Staff Report to the Western Weber Planning Commission

Application Request: Consideration and action on a request for preliminary plan approval of Sunset Equestrian Cluster Subdivision.
Type of Decision: Administrative
Agenda Date: Tuesday, September 12, 2017
Owner: Fieldbrook Taylor Partners, LLC
Authorized Representative: Doug Nosler
File Number: LVS080717

SUNSET EQUESTRIAN Cluster Subdivision

Preliminary Plan

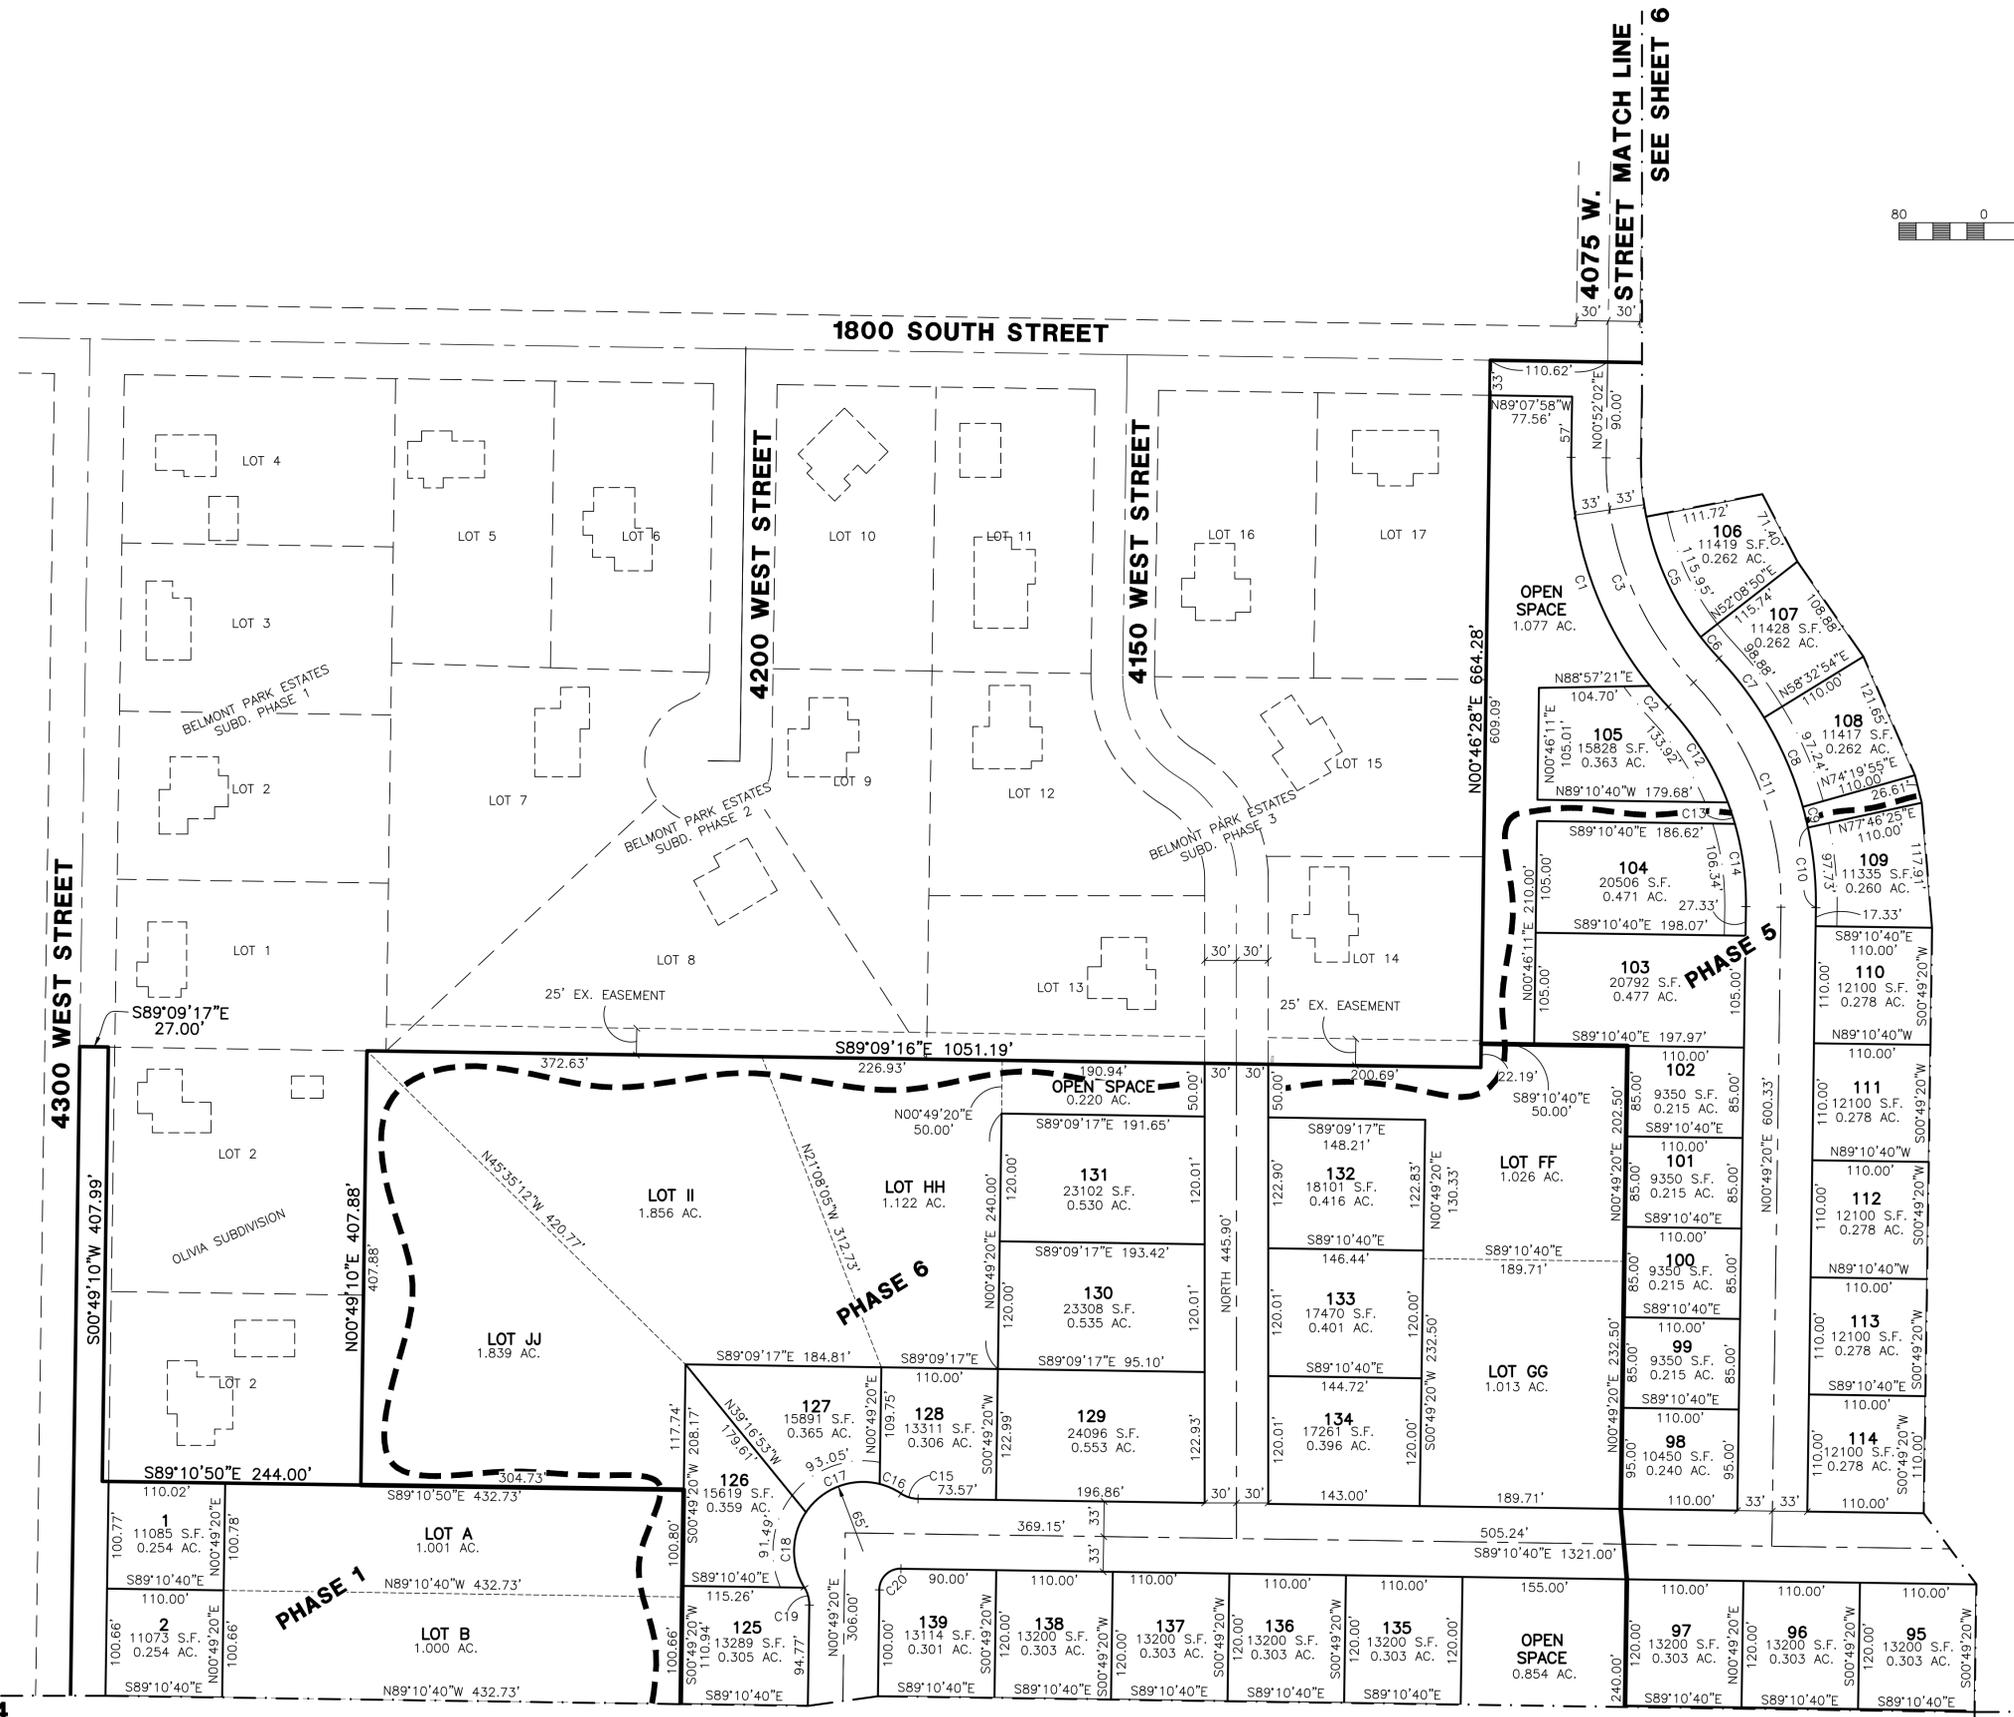
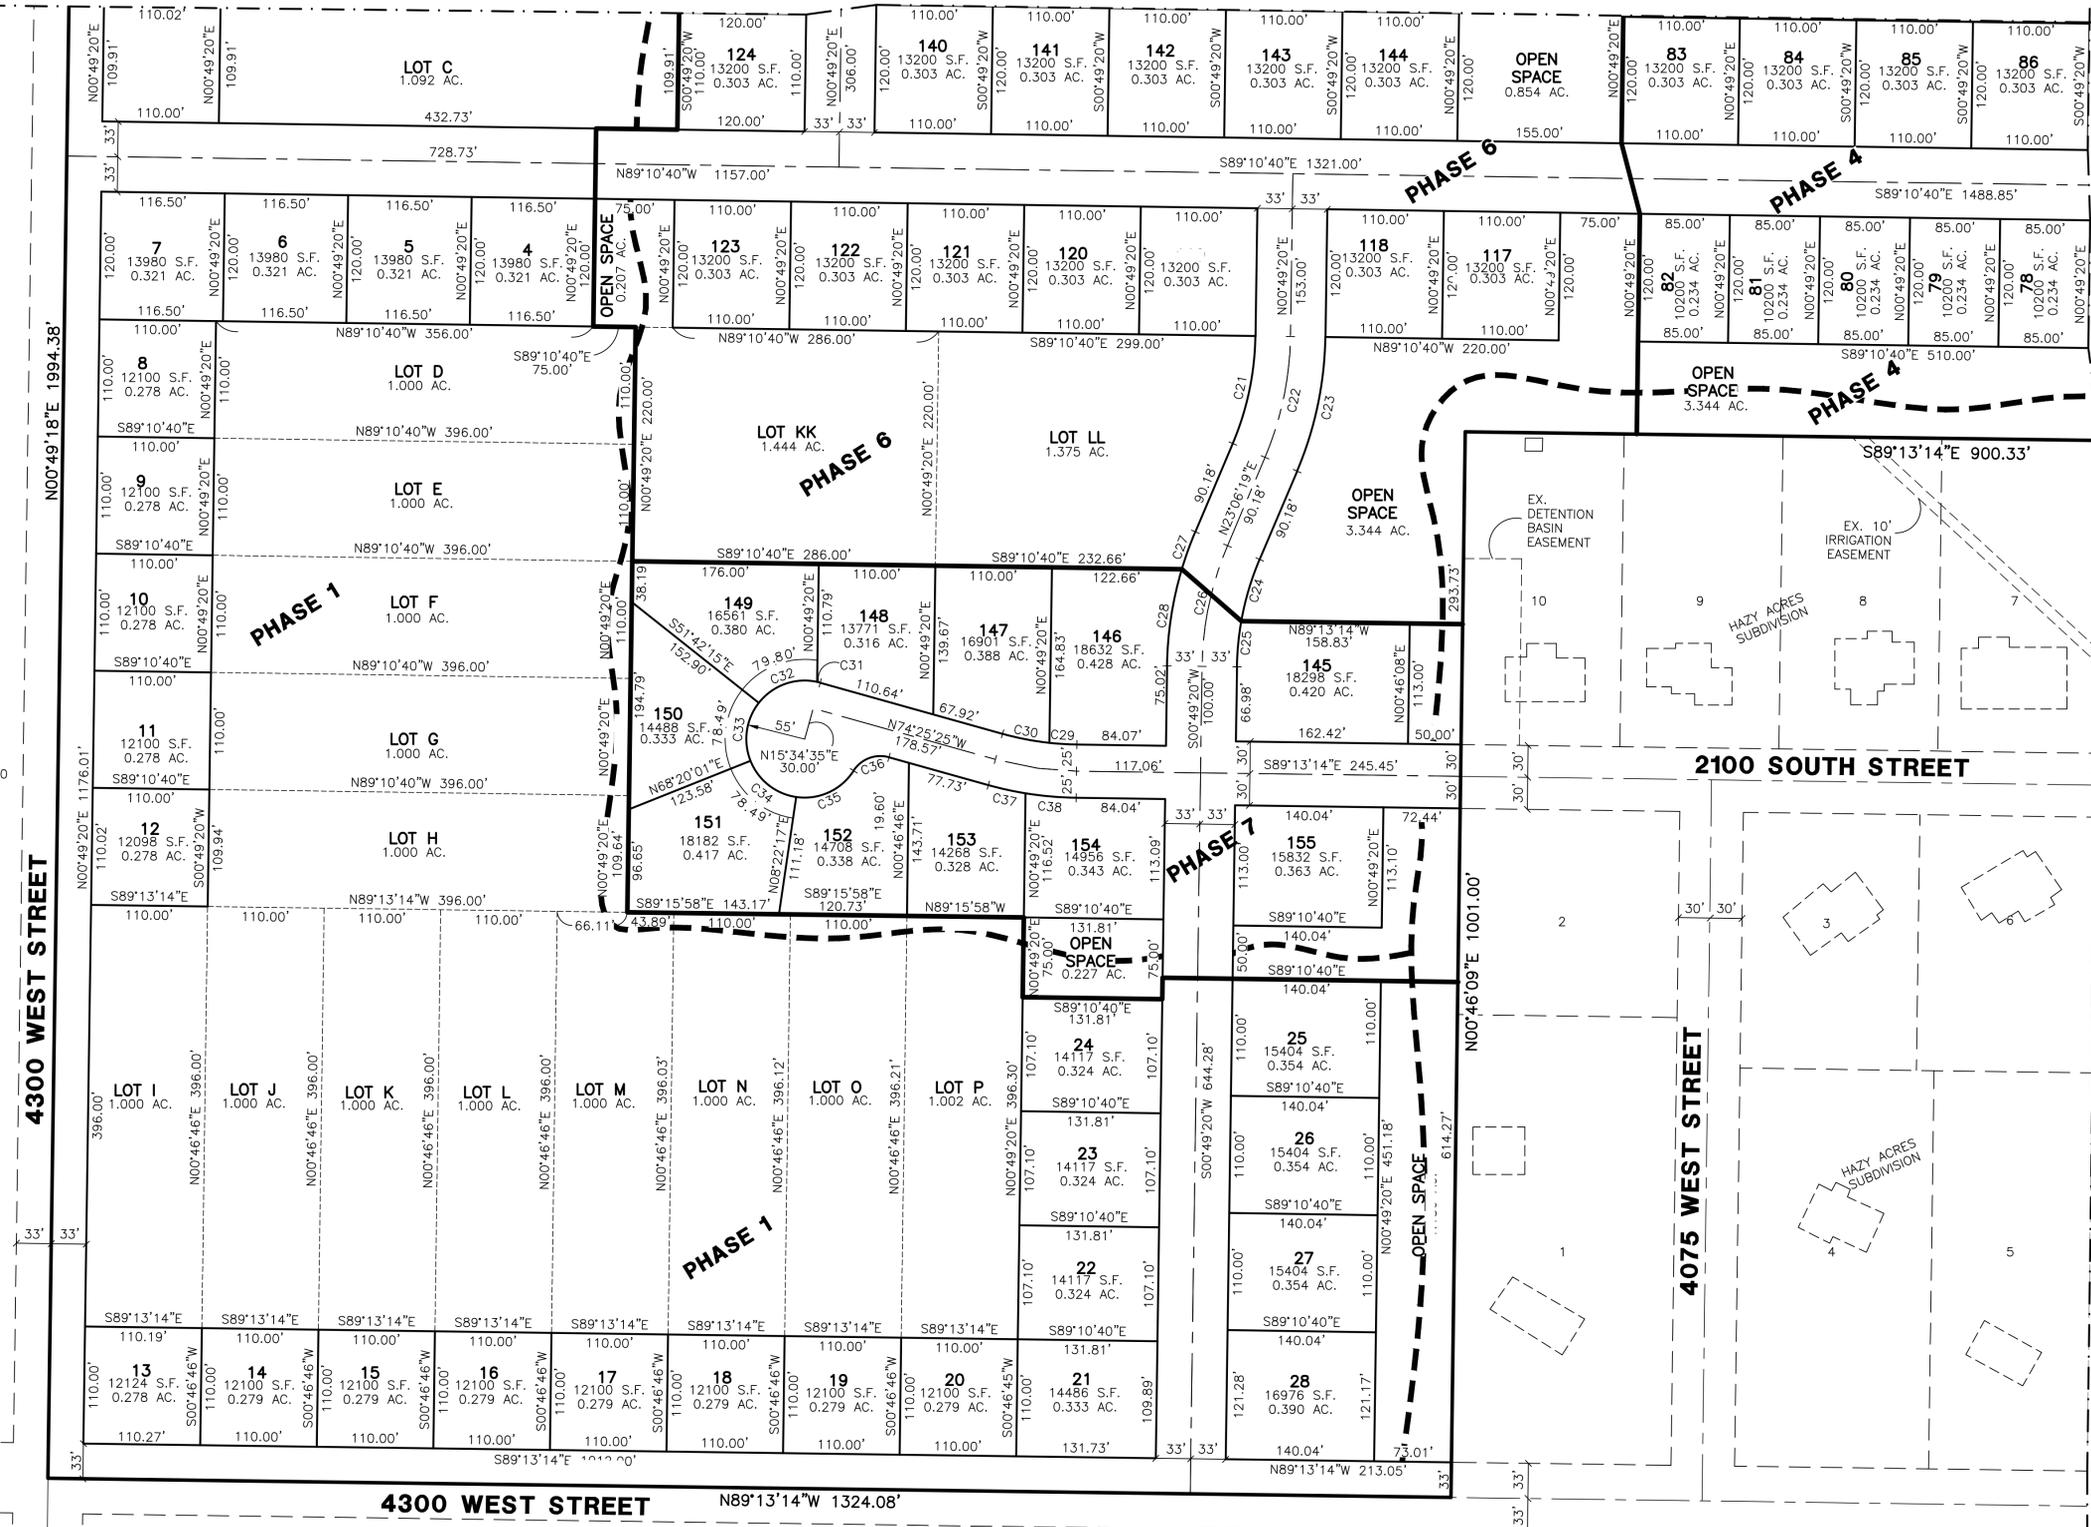
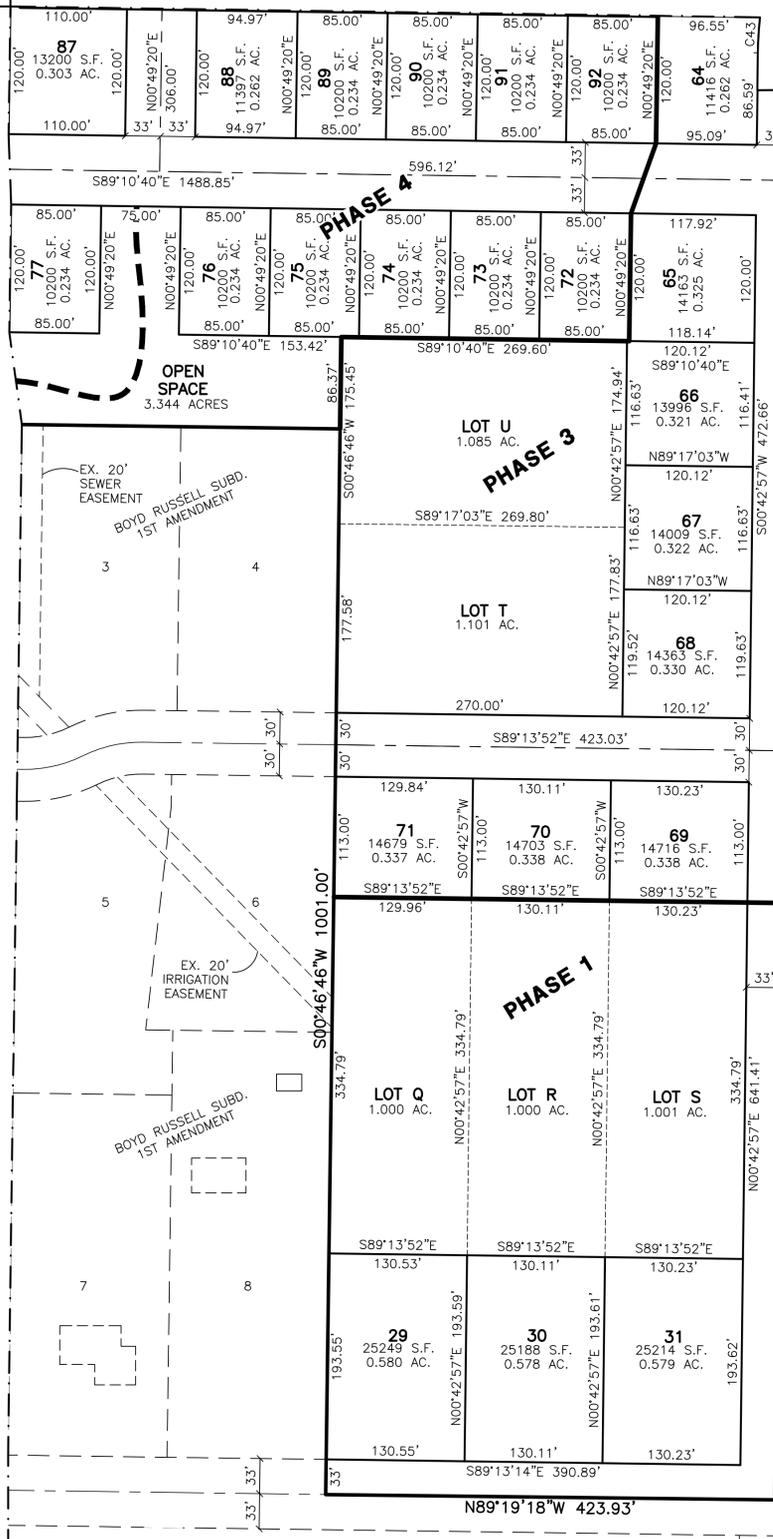
Cluster subdivision design and layout standards: The applicant is proposing curb, gutter, and sidewalk along both sides of all proposed streets, according to the submitted preliminary plan (Exhibit A). All lots within the proposed cluster subdivision meet the minimum lot width requirement of 60' per LUC §108-3-7(2)(c). The proposed cluster subdivision meets the open space width requirements of 75' between clusters of lots per LUC §108-3-4(1). The proposal also consists of several clusters of lots, not exceeding 20 lots per cluster as outlined in LUC §108-3-4-2.

The applicant has proposed to implement walking and equestrian trails within the common area and agricultural open space parcels throughout the subdivision. The location of the proposed trails is on the preliminary subdivision plans (Exhibit A). The West Central Weber County General Plan indicates that equestrian trails are highly desired in the area. The proposed walking and equestrian trails should comply with the multi-purpose trail cross section shown in the West Central Weber County General Plan (2003 *West Central Weber County General Plan: Trails*).

Additional design standards and requirements: The proposed cluster subdivision will have 50', 60', and 66' width dedicated county roads extending through the subdivision to the adjacent property to provide future connectivity to the surrounding area.
